RFI 1. GPA proposes that each new Net Energy Metering Customer may elect to pay the new Energy Storage Rate, or to use a Frequency Control Capability or a new Energy Storage System with the installation of a new solar PV or wind turbine system.

A. Please explain what GPA means by "Frequency Control Capability."

GPA Response for RFI 1-A

Figure 2. DC-Coupled System Example

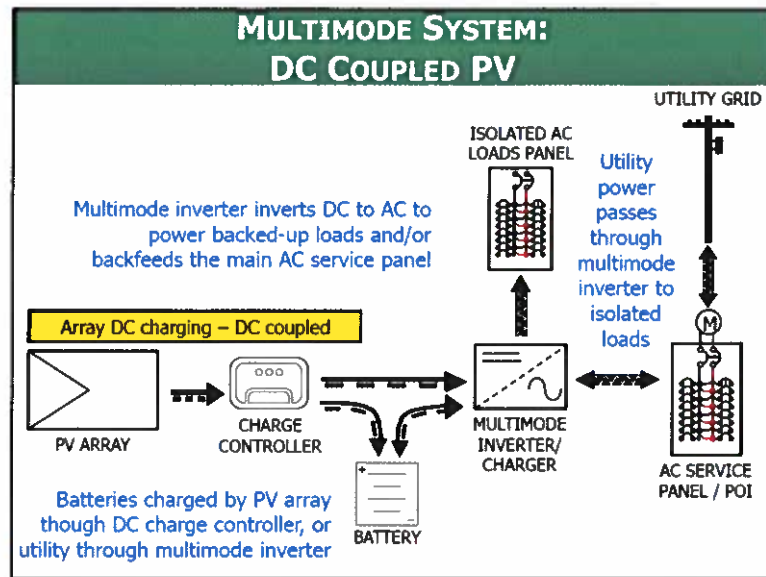
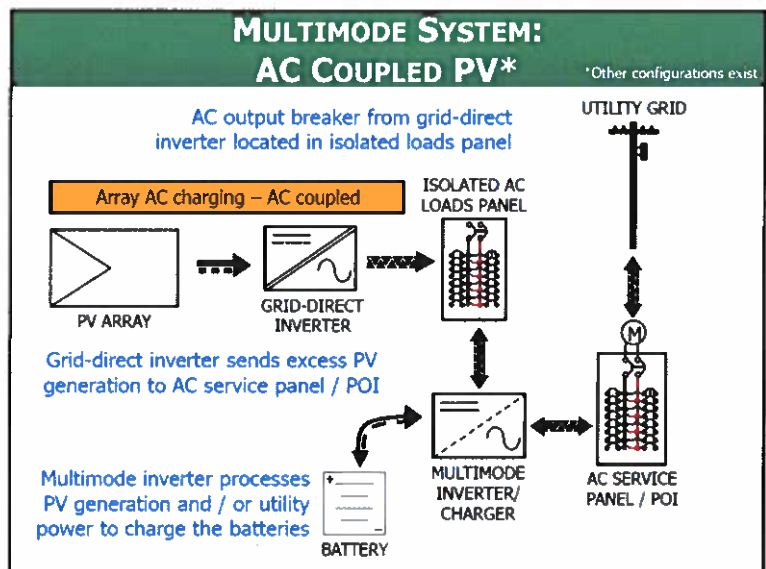
RFI 18. Resolution No. 2020-01 states: "... the PV systems and the energy storage should share the same DC Bus configuration behind one inverter system to reduce SCR burden on GPA and reduce the PV ramping affects due to intermittent solar irradiation...". Please provide a more detailed explanation of the meaning of the last sentence.

SCR is the ratio between system Short Circuit MVA and the combined MVA of inverter-based generation. The more inverter-based generation, the greater the need for additional Short-Circuit MVA to keep a sufficient SCR for safe and reliable operation of these inverters. DC-coupled systems connect the DC output directly to the DC input of the inverter. Thus there is one inverter for the system. AC-Coupled Systems will have a Multimode Inverter and a Grid Tied Inverter. This increases the amount of inverter MVA in the power system.

The Grid-Tied Inverter can provide power into the grid through the multi-mode inverter. The power output would include intermittency. Having the inverter run off the batteries can eliminate intermittent outputs into the grid.

Figure 4. Talofoto BESS Performance

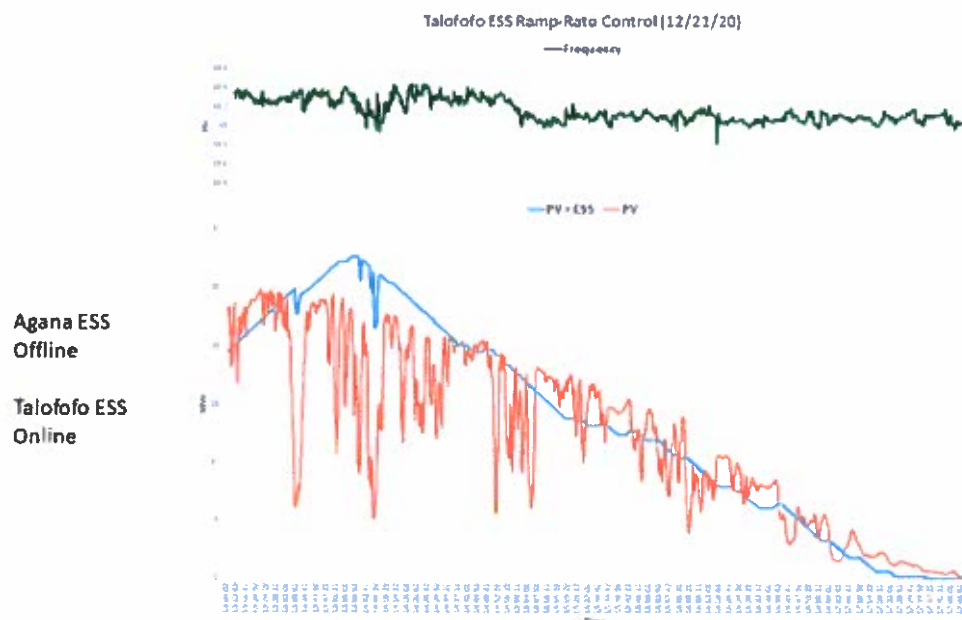
- RFI 19. Is it inconsistent for GPA to require Frequency Control Capability or ESS on new NEM systems, but not to require the same for the as yet unconstructed 120MW solar plants? If not, why not? Won't intermittency or instability caused by the 120MW plants be greater than that caused by 24MW of net metering capacity?

No. The Phase II projects will use BESS to smooth out intermittencies including PV output drop outs. This question is irrelevant because GPA is requiring the Phase II projects to ameliorate intermittency and PV drop outs.

Please refer to Figure 4. The Talofoto BESS remediates the intermittent output of the Dandan solar PV facility using battery energy storage system and system controller. The intermittent output of the Dandan facility is smoothed out (blue line) including the PV output drop outs.

Graph 1 - Under Frequency Load Shedding Events for 2019 **count by Instigator**

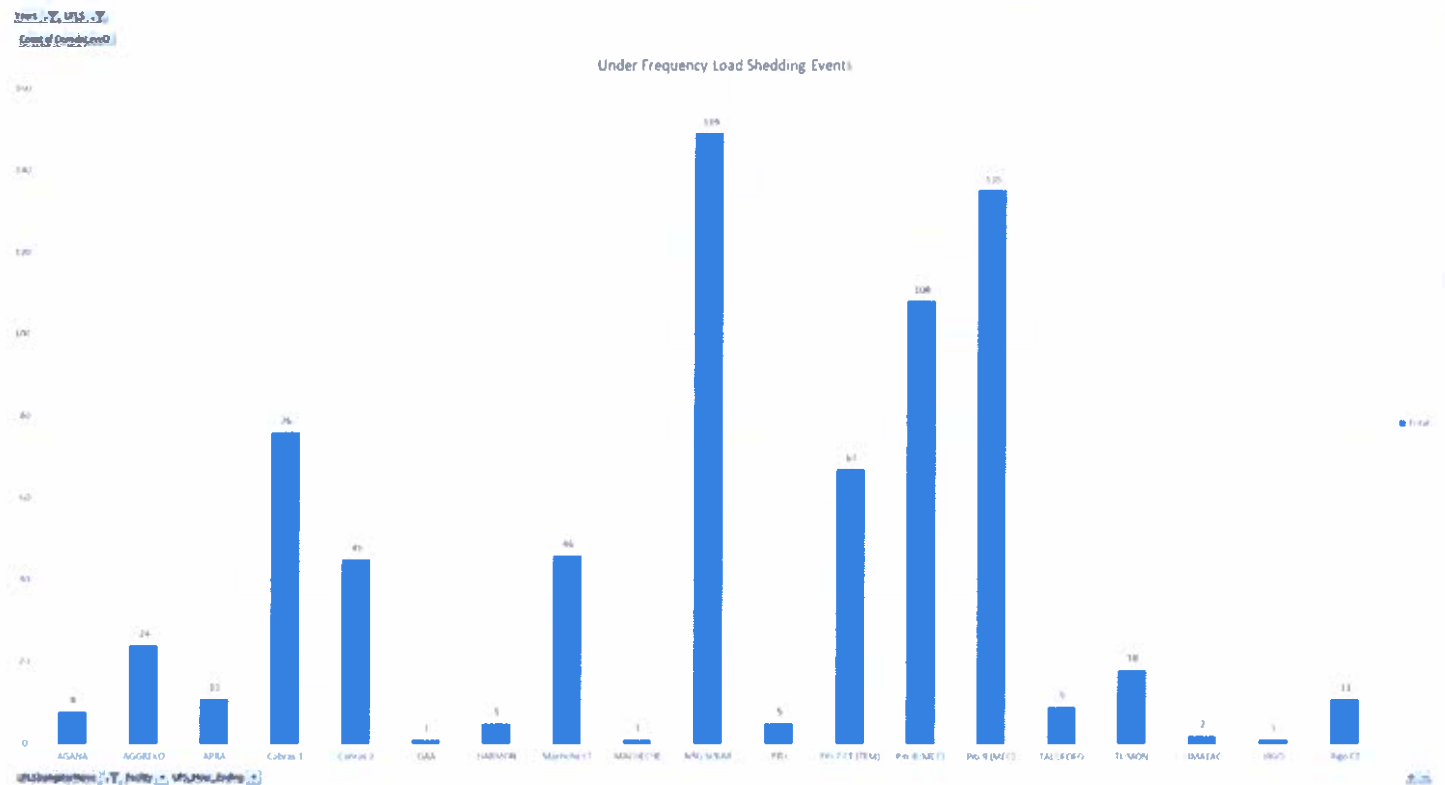
RFI 14. What evidence does GPA have that the 24MW of solar energy produced by NEM Customers has directly caused intermittency to the island's power grid? Please provide all data, analyses, memorandums, and studies demonstrating the root cause analyses for the conclusion stated in the resolution.

Graph 1 shows that NRG Solar totaled 149 events or 23% of the total UFLS generation outages. NRG Solar had the highest count by generation type of UFLS outages in 2019.
